Office of Rail Regulation

**Part A Independent Reporter
Framework**

**Mandate: Review of Coal Spillage
Charge (CSC)**

Final | 17 April 2013

Fig. 2 NR forecast coal tonnages

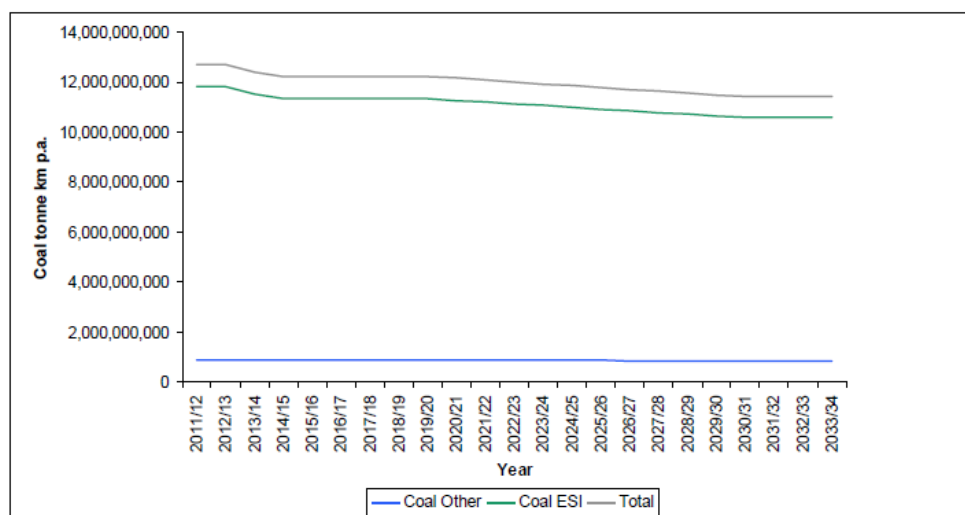
The basis for Network Rail's CSC is the assumed traffic and costs estimated to be incurred in 2014/15. We are comfortable in Network Rail's assumption that for CP5 similar volumes of coal are likely to be carried across the network.

Fig. 3 Coal in points failures show a falling trend in 2011 (Note: NR considers that coal related points failures tend to be under attributed to coal as a root cause)

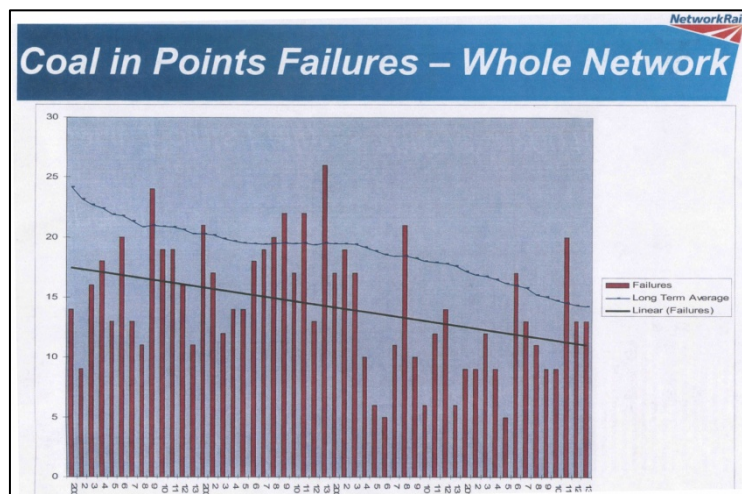
During the interviews with Network Rail Route staff we were told by all Routes that whilst fault recording systems are used to record incidents where points have failed in traffic due to coal spillage, this description of the cause is not always used, making direct reference to the fault system (FMS) an unreliable source of accurate information on which to base the charge. We note this, and make further reference to fault recording in our recommendations.

Fig 16. Chart to demonstrate the lower unit cost of depreciation for track in CP5 (plain line example shown)

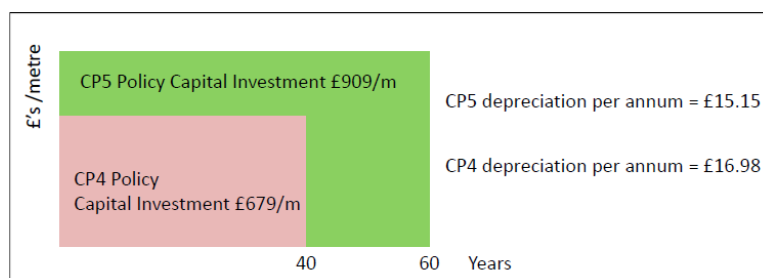
NR, in their CP5 Track Asset Policy, have introduced within their track renewals plans two new types of track refurbishment interventions that they have demonstrated will create a lower whole life cost of track. These are heavy and medium refurbishments. It is the heavy refurbishment that is of interest to the calculation of the CSC. Previously track was renewed as a complete system when one major component was life expired. This might have been the rail, sleeper or ballast. For CP5, the policy will be only to renew that component of the track system that is life expired, and retain the remaining components until one of them triggers the next major intervention. For a heavy refurbishment on both plain line and S&C the ballast will be renewed. NR expects that this single intervention will extend the life of track by 50%. They have applied this principle to the CSC. This can be shown in the following chart:

Following our review of the locations from which coal is loaded and to which it is discharged, we have recalculated the plain line and S&C depreciation charges using the same figures as NR but with reduced miles of plain line and a reduced number of point ends as illustrated.

For plain line track the annual depreciation charge should reduce from £1,673,010 to £1,246,104 (648miles x £1,923/m).

For S&C the calculation is a little more complex as a revised allowance has to be made for the reduced number of point ends to be treated. Using NR's figures for the depreciation cost of untreated point ends as £2,545 and for treated point ends as £1,624, the total depreciation charge for S&C would be 671 (from fig.13) minus 201 (from fig.11) multiplied by £2,545; plus the depreciation charge for treated point ends which is 201 multiplied by £1,624. This gives a total annual charge of £1,522,574.
